U.S. Department of Energy
Office of Civilian Radioactive Waste Management

Engineered Barrier System Design and Fabrication NRC Item 7(e.1), 7(e.2), and 7(e.4)

Presented to:
NRC/DOE Preclosure Issues Technical Exchange

July 24-26, 2001

View of Emplacement Drift Rail

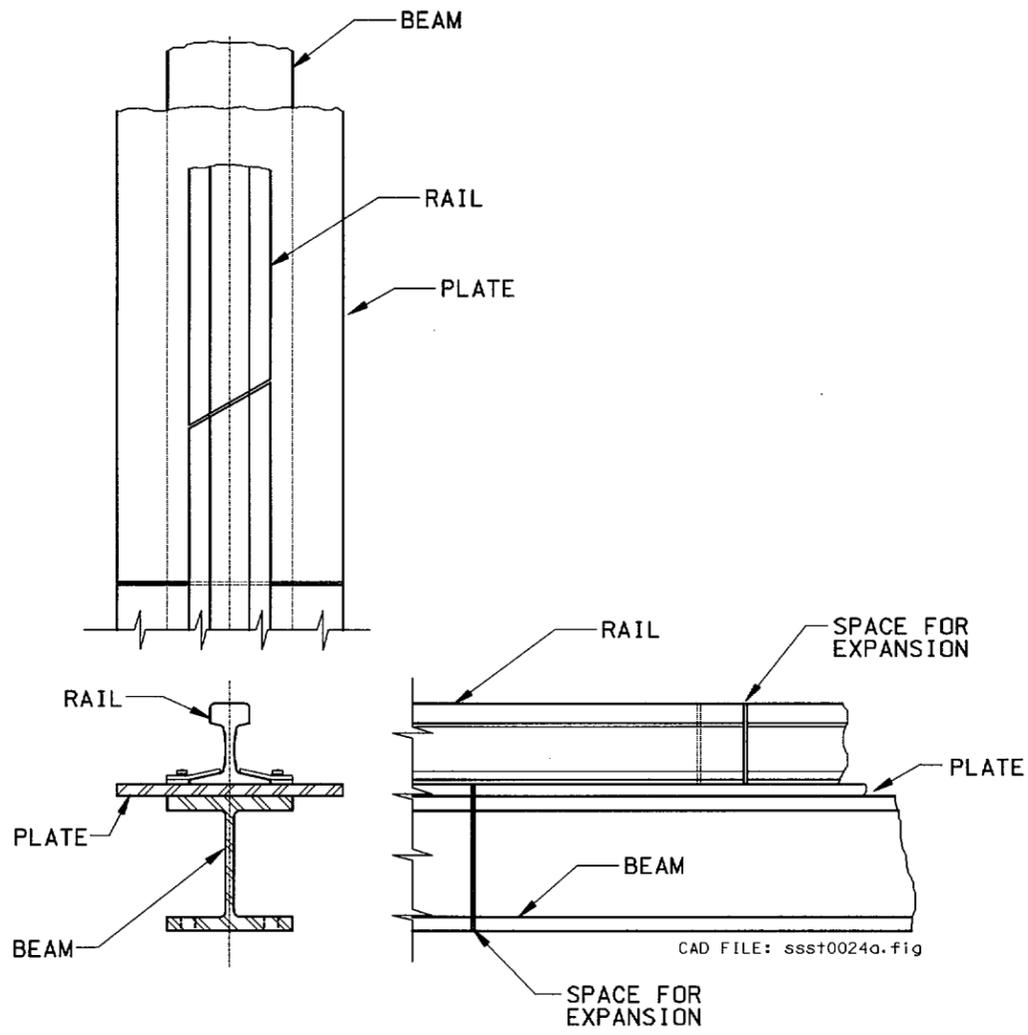
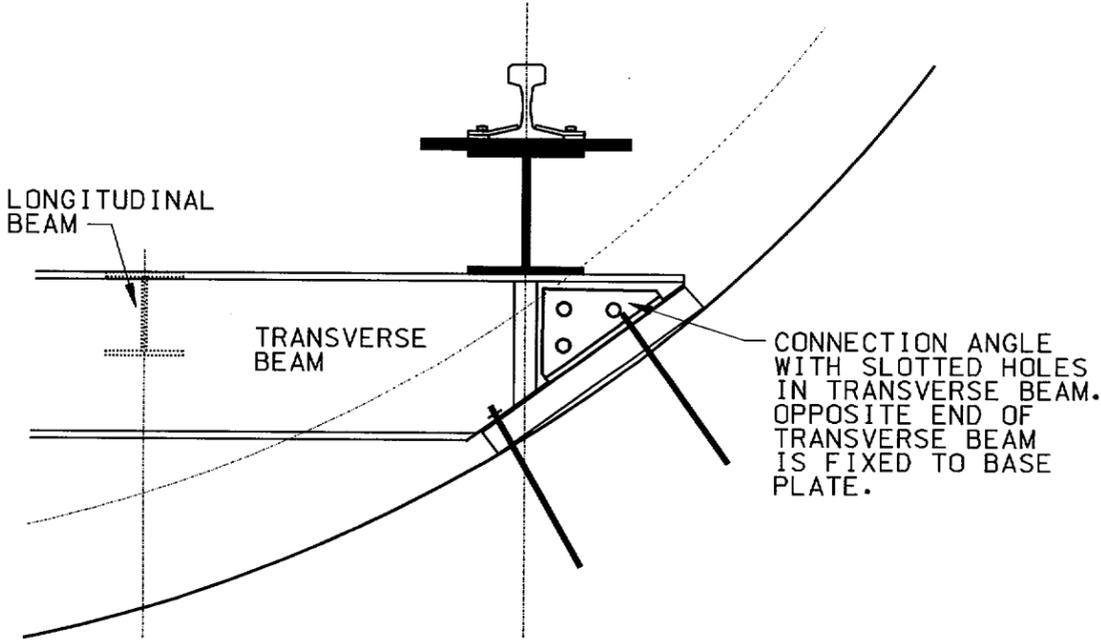
NRC Comment:

DOE Response: (Invert transfer beams)

- **Invert transfer beams are anchored on one end, and feature a slotted connection on the other end, allowing for expansion**
- **Preliminary estimate of a typical transfer beam expansion is about 0.13 inches at 200°C**
- **Design not yet detailed, and the invert configuration may change for LA**

LONGITUDINAL BEAMS WILL BE FIXED AT ONE END AND ALLOWED TO EXPAND AT OPPOSITE END.

Figure 8-1. Quality Level Classification Criteria, RSS,
TDR-WIS-RL-000001 REV 04 ICN 01

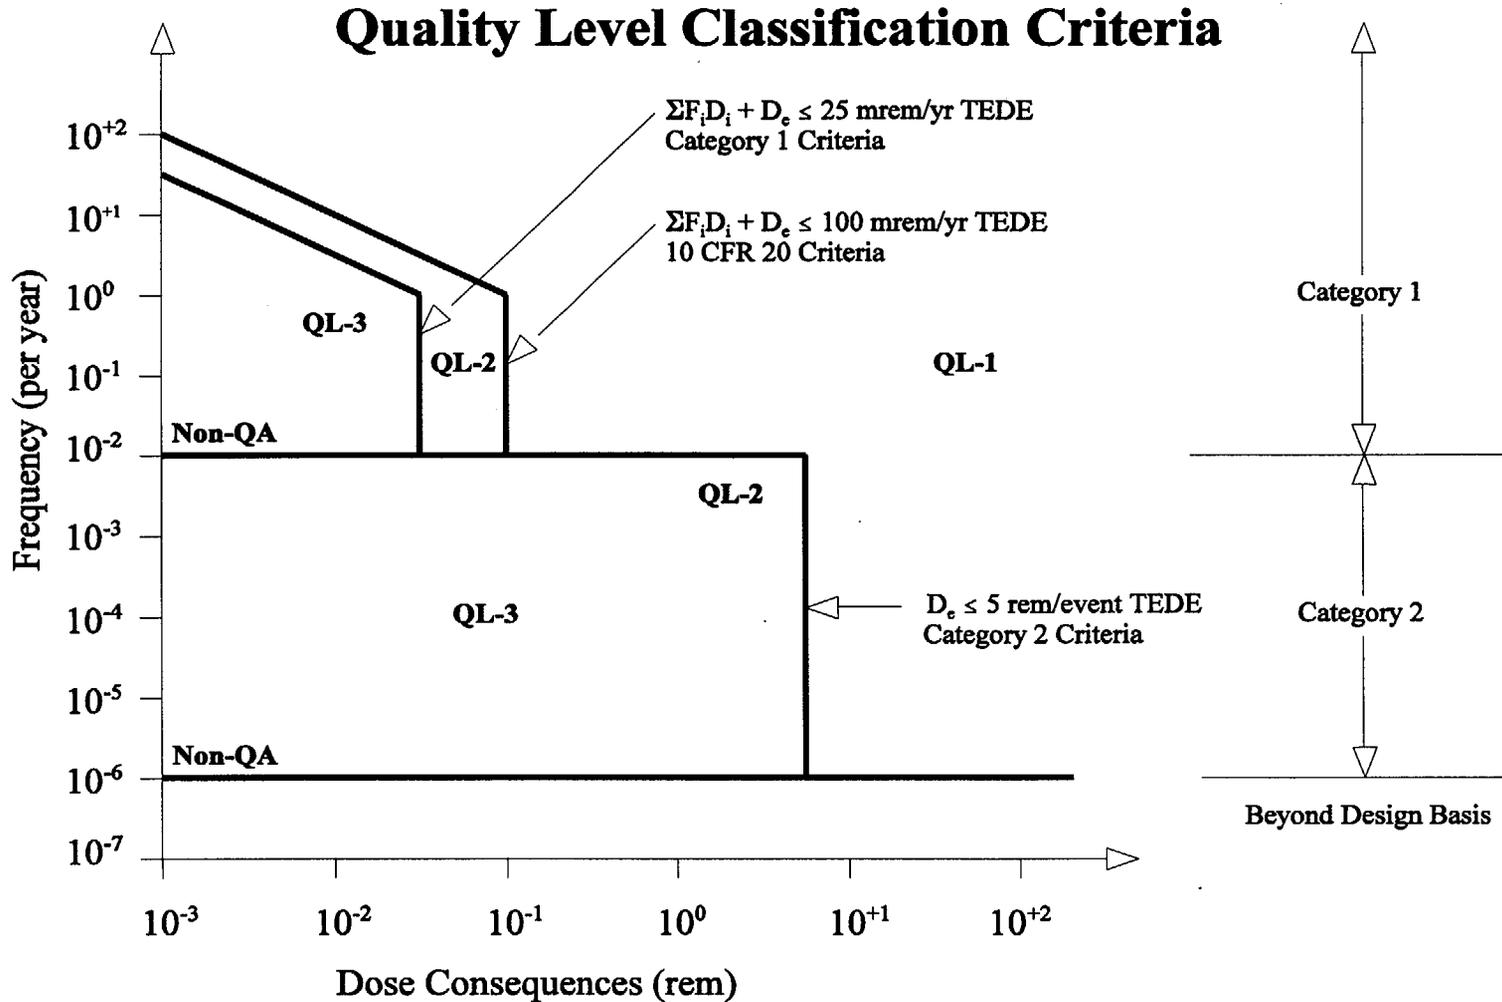
1. Additional explanation and examples are required to show how DOE proposes to integrate in a transparent manner, the use of the equation $\sum F_i D_i + D_e$ (RSS Figure 8-1), the "take away" analyses (RSS Section 8), the screening criteria in procedure QAP-2-3, and the classification analyses.
2. Clarification is required as to how DOE is proposing to include multiple category 1 event sequences in the proposed categorization process.

3. Clarification is required as to whether the routine releases from surface and subsurface facilities during normal operational are factored into the equation $\sum F_i D_i + D_e$ (RSS Figure 8-1).
4. Additional explanation is required regarding the establishment and use of the bounding dose term (D_e) in the Q-list and categorization process.
